Access Compliance Report

Public Rights-of-Way

(Curb Ramps)

Intersection ID: N/A	Main Street: DELPOND LN	Cross Street: SUTTON_SPRINGS_RD	Location: E
ADA ID: DCE97EFE4B08	Ramp Type: Perp	Initial Pass/Fail: Fail	Overall Compliance: No
Codes/Mitigation Info/Possible Solution		Field Measurements/Component Compliance	
Severity Score: 21.25

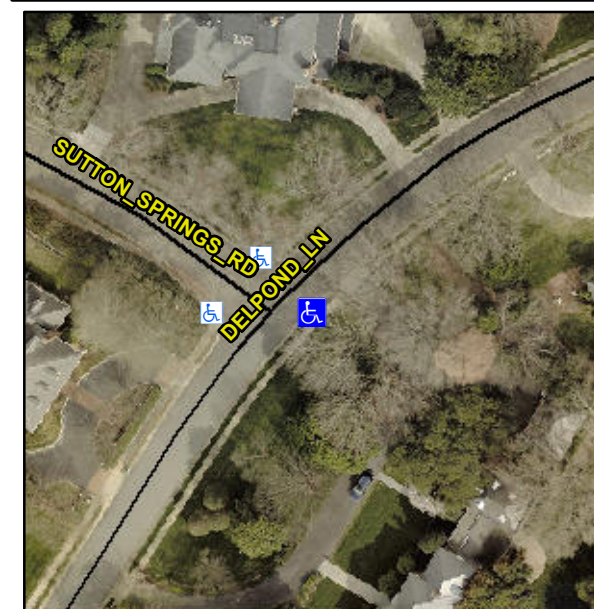
Not Found, R304.5.1, R304.5.3

Compliance	Description	Data	Compliance	Description	Data
N/A	Ramp Length (in)	34.0	Yes	Ramp Slope (%)	7.2
No	Ramp Width (in)	45.0	No	Ramp XSlope (%)	6.9
N/A	Flare Type LT	N/A	N/A	Flare Type RT	N/A
N/A	Flare Slope LT (%)	N/A	N/A	Flare Slope RT (%)	N/A
N/A	Flare Traversable LT?	N/A	N/A	Flare Traversable RT?	N/A
N/A	Landing Length (in)	N/A	N/A	DWS Provided?	N/A
N/A	Landing Width (in)	N/A	N/A	DWS Contrast?	N/A
N/A	Landing Slope (%)	N/A	N/A	DWS Length (in)	N/A
N/A	Landing X Slope (%)	N/A	N/A	DWS Full Width?	N/A
N/A	Landing Curb? (Y/N)	N/A	N/A	DWS Offset (in)	N/A
N/A	Shared Landing?	N/A			
N/A	Gutter Ponding?	N/A	N/A	Gutter Slope (%)	N/A
N/A	Gutter Lip Ht (in)	N/A	N/A	Gutter X Slope (%)	N/A
N/A	Painted X Walk1?	No	N/A	Painted X Walk2?	N/A
	X Walk 1 Direction	To NW		X Walk 2 Direction	N/A
N/A	X Walk 1 Width (in)	N/A	N/A	X Walk 2 Width (in)	N/A
	X Walk 1 Slope (%)	2.3		X Walk 2 Slope (%)	N/A
	X Walk 1 X Slope (%)	4.7		X Walk 2 X Slope (%)	N/A

Remove & Replace Entire Ramp.
